Access Compliance Report

Public Rights-of-Way

Intersection ID: 31318	Main Street: DEERTON_RD	Cross Street: OLD_POTTERS_RD	Location:	E
ADA ID: D8616198F99D	Ramp Type: Perp	Initial Pass/Fail: Fail	Overall Compliance: No	Severity Score: 12.5
Codes/Mitigation Info/Possible Solution		Field Measurements/Component Compliance

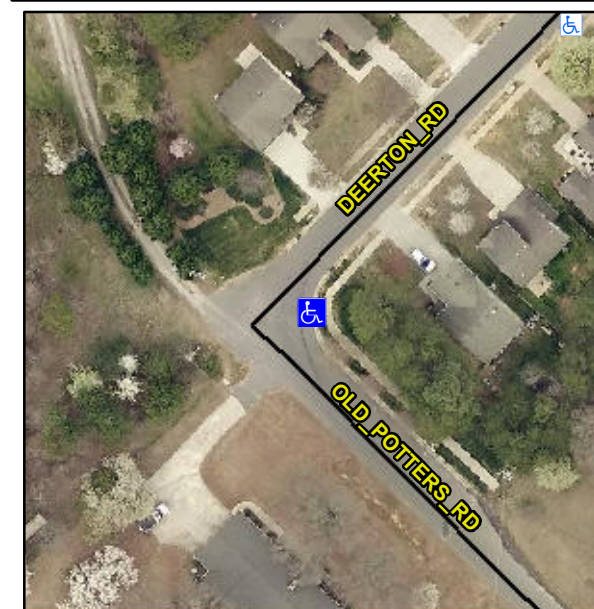
Not Found, R304.2.2

Compliance	Description	Data	Compliance	Description	Data
N/A	Ramp Length (in)	47.5	No	Ramp Slope (%)	8.6
Yes	Ramp Width (in)	54.5	Yes	Ramp XSlope (%)	2.0
N/A	Flare Type LT	N/A	N/A	Flare Type RT	N/A
N/A	Flare Slope LT (%)	N/A	N/A	Flare Slope RT (%)	N/A
N/A	Flare Traversable LT?	N/A	N/A	Flare Traversable RT?	N/A
N/A	Landing Length (in)	N/A	N/A	DWS Provided?	N/A
N/A	Landing Width (in)	N/A	N/A	DWS Contrast?	N/A
N/A	Landing Slope (%)	N/A	N/A	DWS Length (in)	N/A
N/A	Landing X Slope (%)	N/A	N/A	DWS Full Width?	N/A
N/A	Landing Curb? (Y/N)	N/A	N/A	DWS Offset (in)	N/A
N/A	Shared Landing?	N/A			
N/A	Gutter Ponding?	N/A	N/A	Gutter Slope (%)	N/A
N/A	Gutter Lip Ht (in)	N/A	N/A	Gutter X Slope (%)	N/A
N/A	Painted X Walk1?	No	N/A	Painted X Walk2?	N/A
	X Walk 1 Direction	To N		X Walk 2 Direction	N/A
N/A	X Walk 1 Width (in)	N/A	N/A	X Walk 2 Width (in)	N/A
	X Walk 1 Slope (%)	1.2		X Walk 2 Slope (%)	N/A
	X Walk 1 X Slope (%)	2.9		X Walk 2 X Slope (%)	N/A

Remove & Replace Entire Ramp.
